WINTER GARDEN
CITY OF WINTER GARDEN
DEVELOPMENT REVIEW COMMITTEE
MINUTES
JUNE 18, 2025

Agenda Item #3.A: E Crown Point Complex – Rezoning

Agenda Item #3.B: Resurrection Catholic Church Renovations – Site Plan

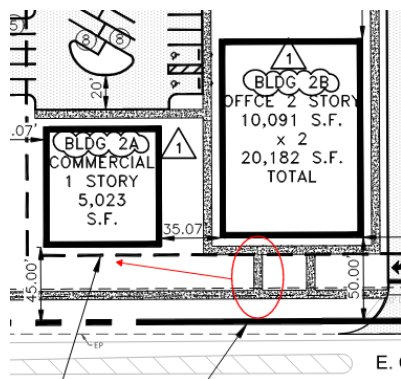
- a. **The response-to-comments letter states that Building 2C will be part of Phase 1. This is still showing in Phase 2.** Applicants will address.
- b. **The phasing on Sheet C-3 goes from north-to-south Phase 1B, then 3B, and 2B. Is this a mistake or the intended phasing? The buildings were relabeled to match the phasing as requested by staff which has it 1B, 2B, and 3B, in that order. Please clarify or revise the phasing.** Applicants will clarify phasing.
- c. **The applicant is missing a sidewalk along Crown Point Cross Road.** Applicants will add a sidewalk.
- d. **The applicant is missing sidewalk connections from the Crown Park Circle and Crown Point Cross Road ROW sidewalks.** Applicants will add the connections.
- e. **Why is there such a large expanse of space in the north portion of Phase 1?** Applicants will show area as landscaping.

- f. **Why does Building 2B have two sidewalk access points while Building 2A has none? Please move and make sure that all buildings have sidewalk access from the front of the property.** Applicants will have the Landscape Architect correct.

17. PCD Uses:

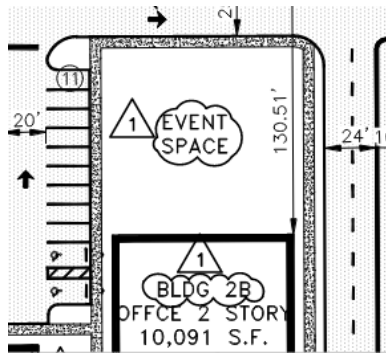
- a. **Repeat comment: Due to the disparity in uses requested, building types, and phasing, the uses must be delineated. This needs to be called out by Phase and Building. As an example, restaurant will not be allowed in Building 3C and retail will not be allowed in Building 2D, etc. However, this is not clearly called out. Note: If the applicant does not provide this Staff will itemize them in the body of the rezoning Ordinance.** Applicants will address uses on the plans and provide examples.
- b. **What is the “Event Space”? This needs to be defined in the uses.** Applicants stated the Event Space is a grass area for employees not an event space. City staff requested applicants describe intended uses of the area in the PD. Applicants understood.
